LEON CREEK WRC RAS PUMP STATION REPLACEMENT PROJECT

Job No.: 16-6509

ADDENDUM 1

January 19, 2017

1 RAS PUMP STATION NO. 2 PLAN
M-01

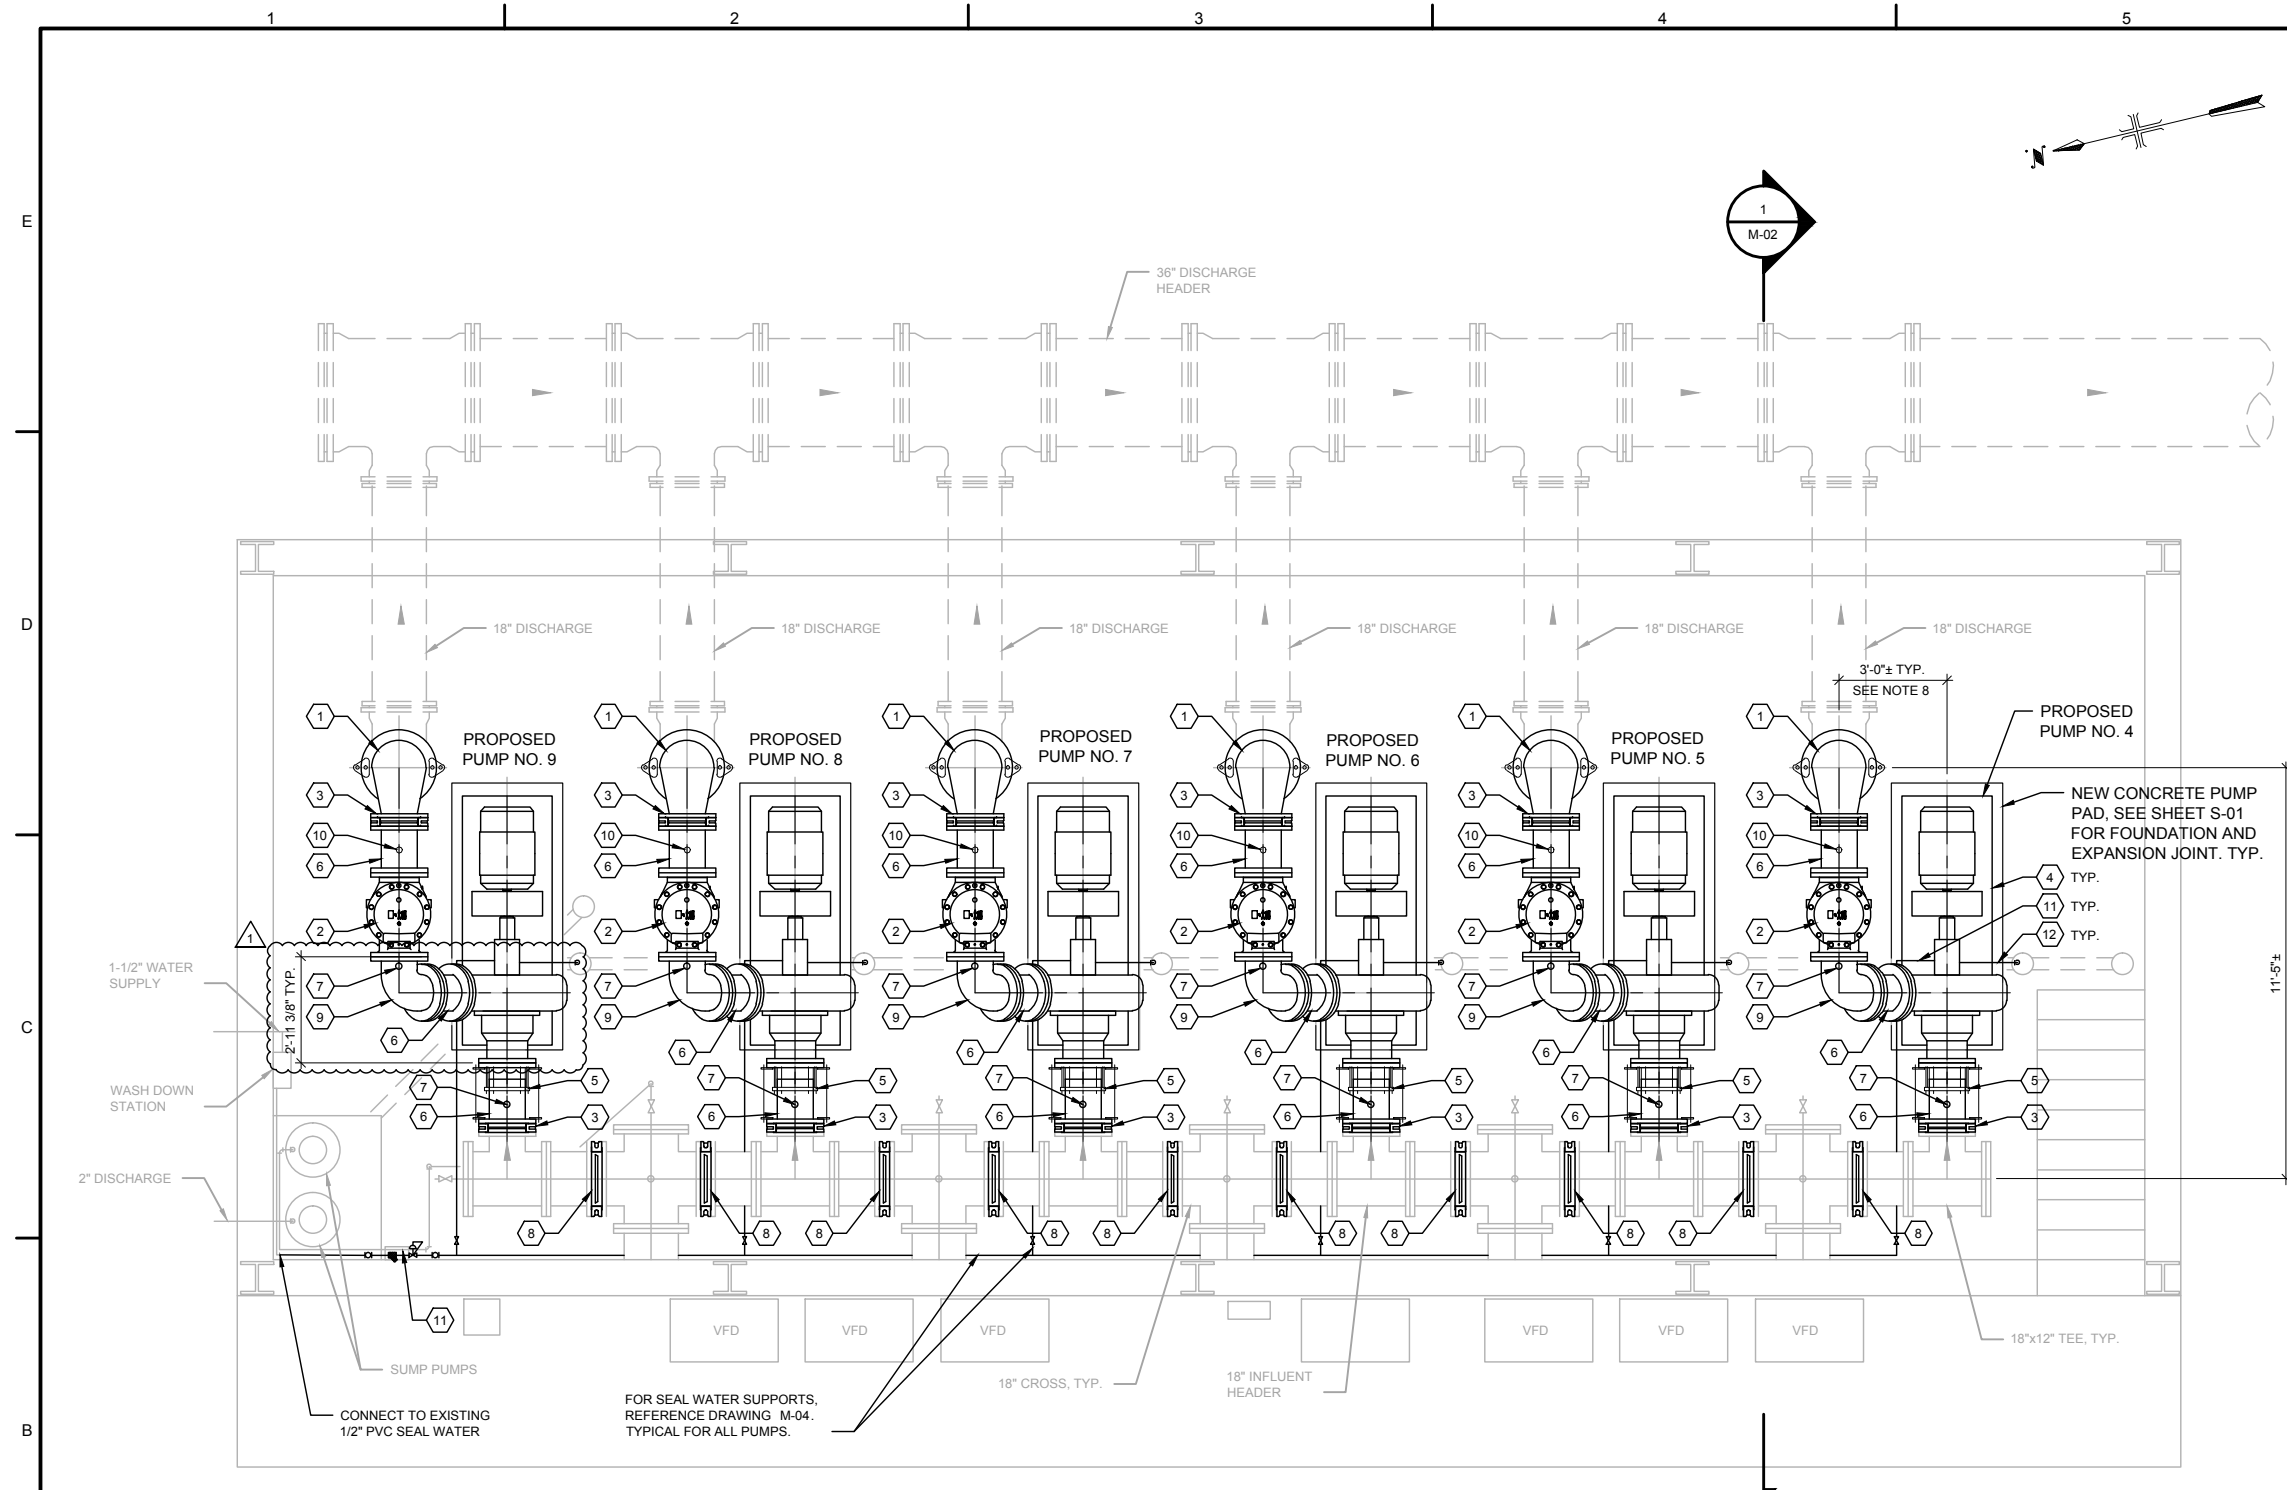
1. Sheets M-01 and M-02 – Replace the sheets with the attached.
 - a. Additional dimensions were included.
2. Sheets I-02 and I-03 – Replace the sheets with the attached.
 - a. Numbering of Clarifiers was updated.

SHEET TITLE
 PROCESS AND INSTRUMENTATION
 RAS PUMP STATION NO. 1

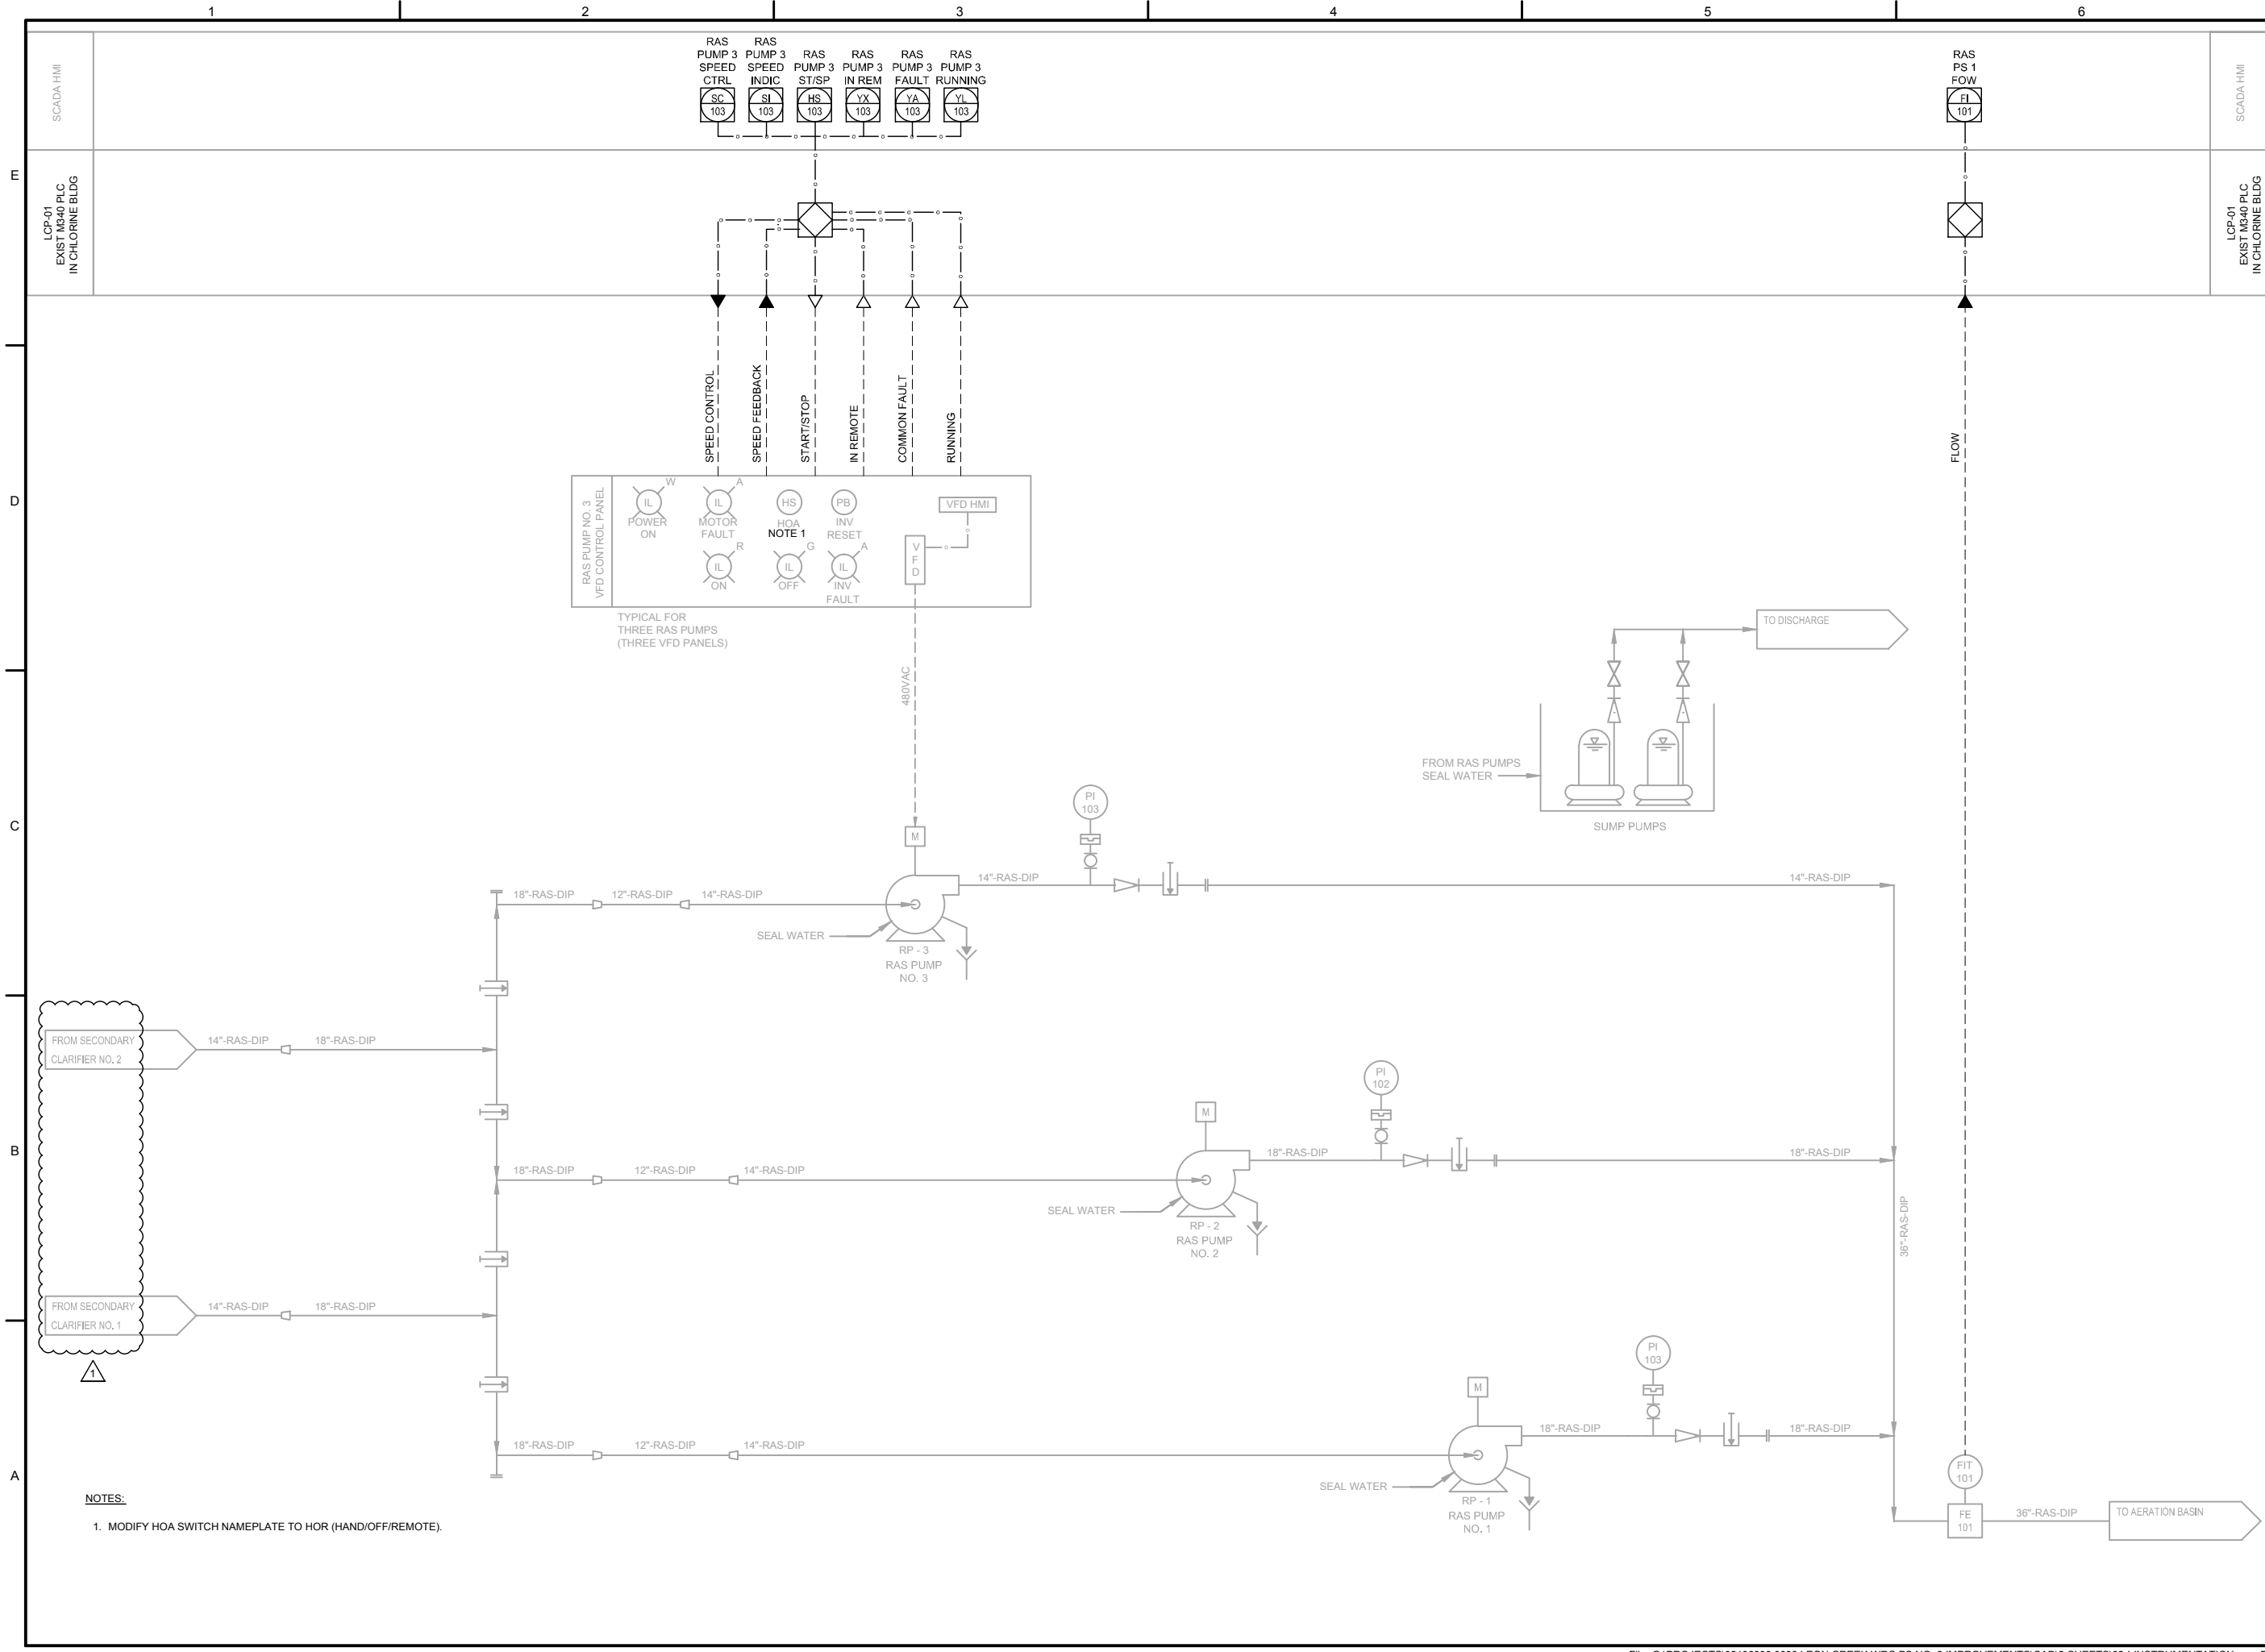
7. **Ref. Spec 01 14 16 4, Drawing Sheet I-03 - The shutdown sequence indicates RAS PS #2 is fed from secondary clarifiers #3 thru #7. Sheet I-03 indicates the pump station is fed from secondary clarifiers #1 thru #5. What is correct?**

Response: RAS Pump Station No. 2 is fed from secondary clarifiers No. 3 thru No. 7. Refer to the revised sheets I-02 and I-03 included in this Addendum No. 1.
